TOWN OF OCEAN CITY

ADDENDUM # 1: Ocean Bowl Admin Building

Date of Addendum: 6/10/24

OCEAN BOWL ADMIN BUILDING
3RD STREET/ ST. LOUIS AVENUE
OCEAN CITY, MARYLAND

Dwg No.: **E-101**

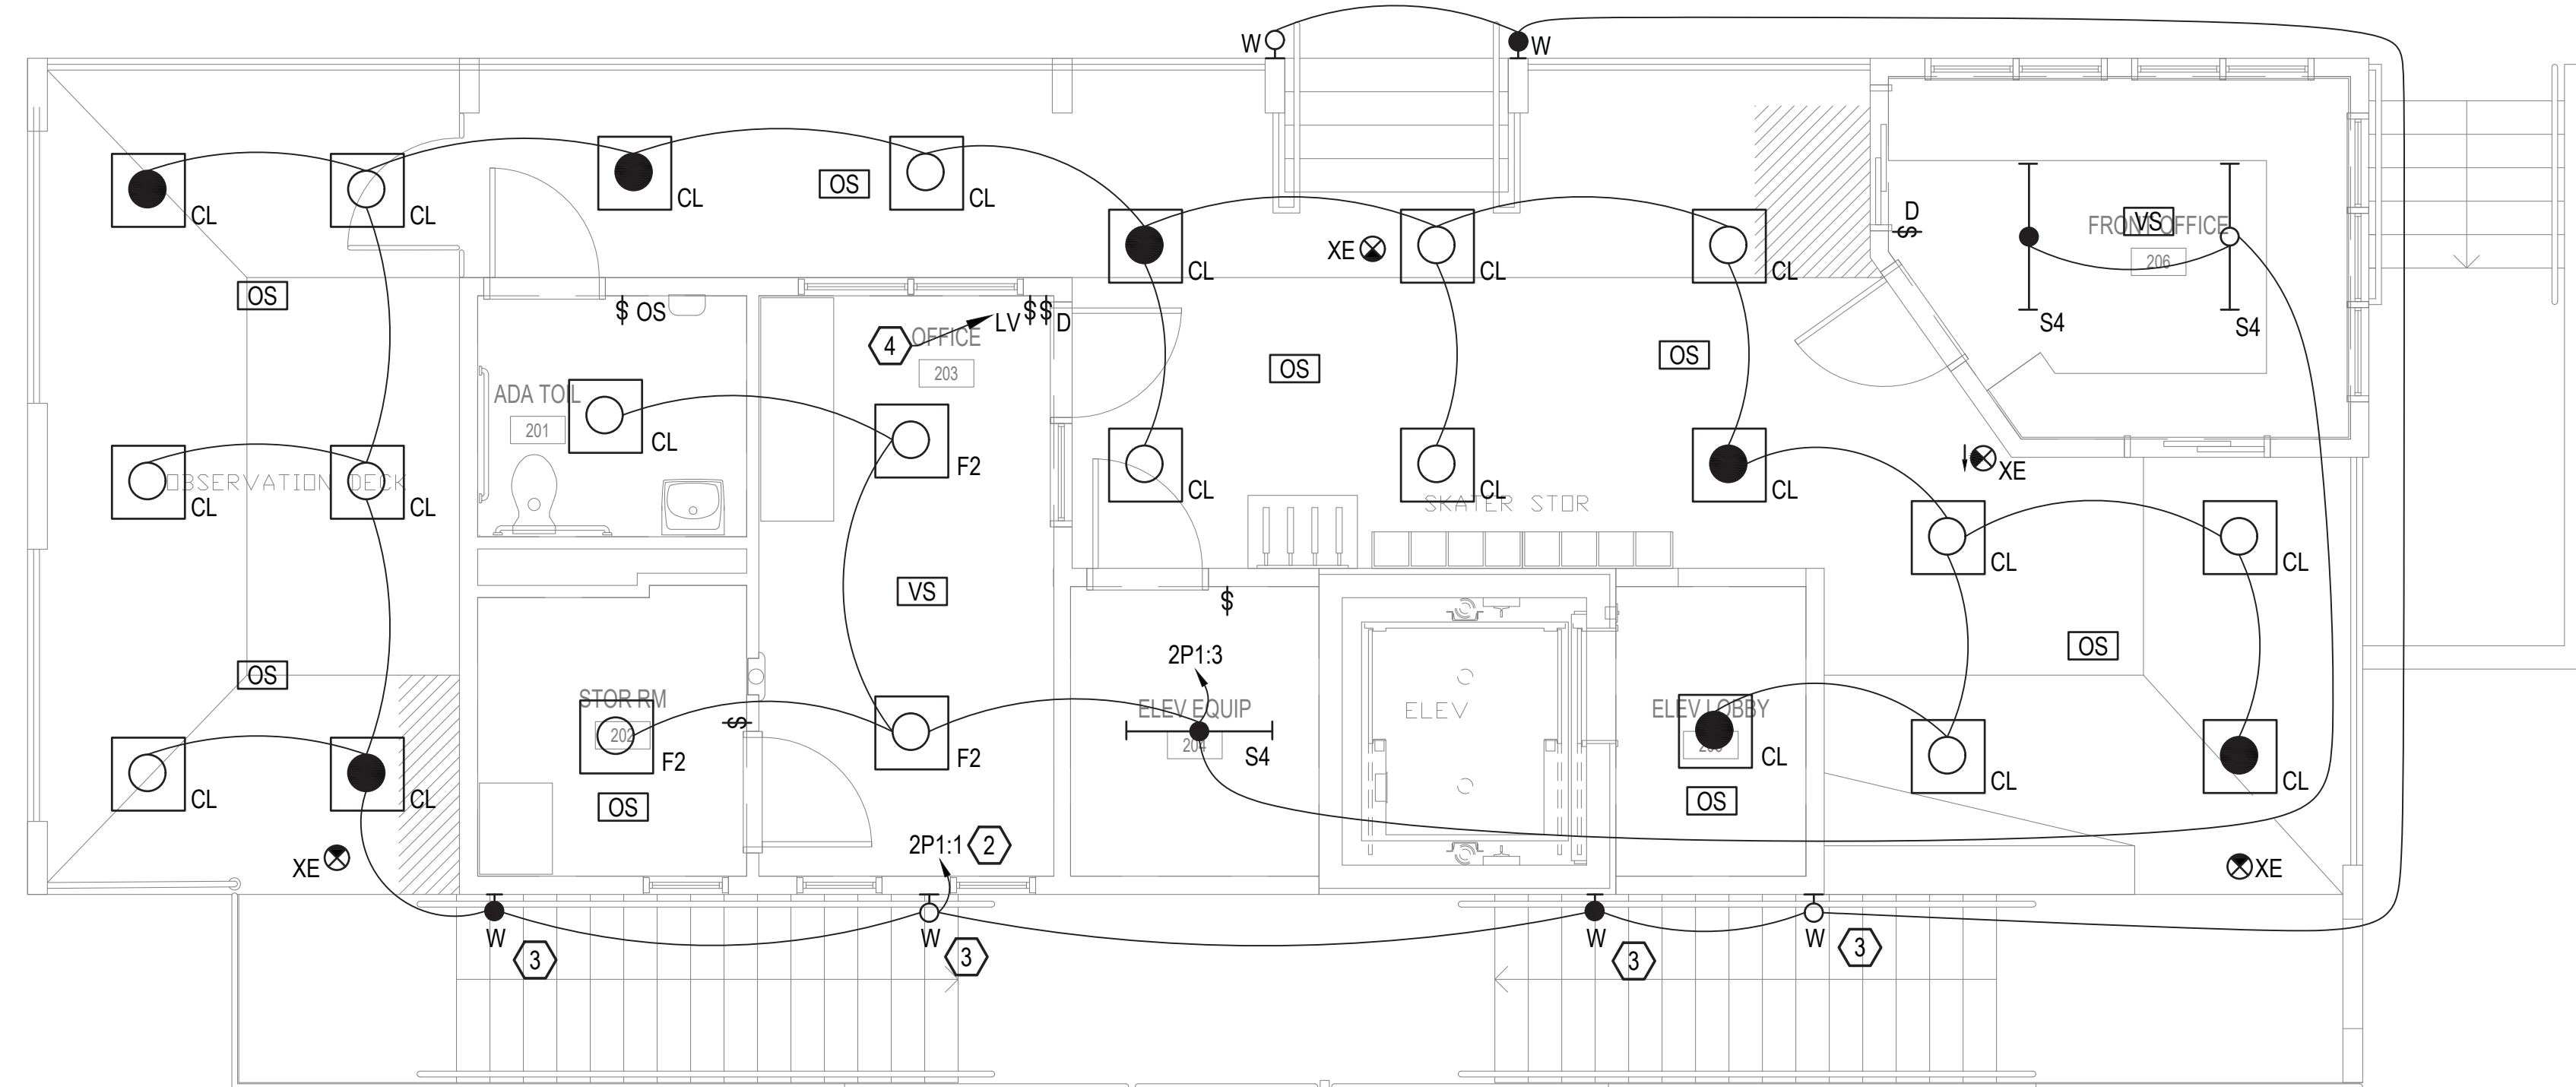
2.5	Referencing the overall project wage scale is not a requirement, correct? Refer to Scope of Work, Section #1-General, Item k.
2.6	There is a discrepancy in the light lay out and count between sheet A-103 Reflected ceiling print and sheet E-101 lighting floor plan. A – 103 shows CL lighting to be vandal resistant, there are 2 that are Not marked, plus the 2 that are missing, I believe all the CL fixtures Should be vandal resistant as they are all in common areas. Also, there are 3 lights in the elevator pit marked VL on sheet E – 101 The fixture schedule on sheet E – 301 has no listing for a VL fixture, It does list an LW, which I believe are the pit light fixtures. A-103 has been revised to show all the lights in common areas to be vandal resistant. LW is the fixture to be used in the Elevation Pit, it is to be as follows: Lithonia DMW2 L24 4000LM PCL MD MVOLT GZ10 40K 80CRI

NO.	DATE	REVISION
1	04/17/2024	REVISED LIGHT FIXTURE
